## TechInfo-026

### Guardus G3-V9 (500.00026) and G3-V9-L (500.00027) new firmware 6.1

May 23<sup>th</sup> 2016: Contronics announces the new 6.1 Guardus G3-V9 firmware which is suitable both to the 1.5V alkaline version (500.00026) as to the lithium 3.6V version (500.00027).

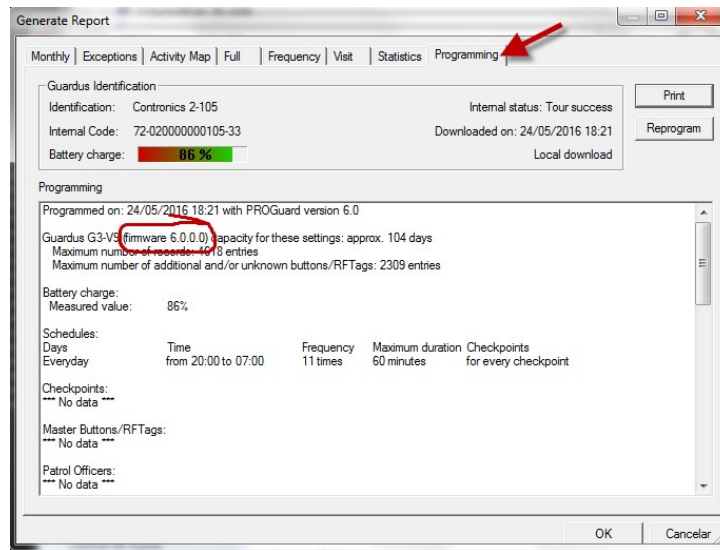
See next an example showing a Guardus G3-V9 with old firmware 6.0, which needs to be updated to the new 6.1:

How to update Guardus G3-V9 to the new 6.1 firmware:

- Navigate in [www.contronics.com](http://www.contronics.com). Click on “support”. On the “Driver” or “Firmware” menu pick option “Guardus G3-V9 Firmware 6.1” and download it. You will get the file **g3\_np09.6.1.0.cfw**.
- Move file **g3\_np09.6.1.0.cfw** to the folder **C:\Program Files(x86)\Contronics\Common Files\SAF32**
- Start Proguard and download Guardus G3-V9. After download is completed a screen will pop asking if you want to upgrade firmware. Accept it. IMPORTANT: The firmware update process will take some minutes; during this time keep Guardus G3-V9 firmly in contact with the interface and do not disconnect neither interrupt communication.
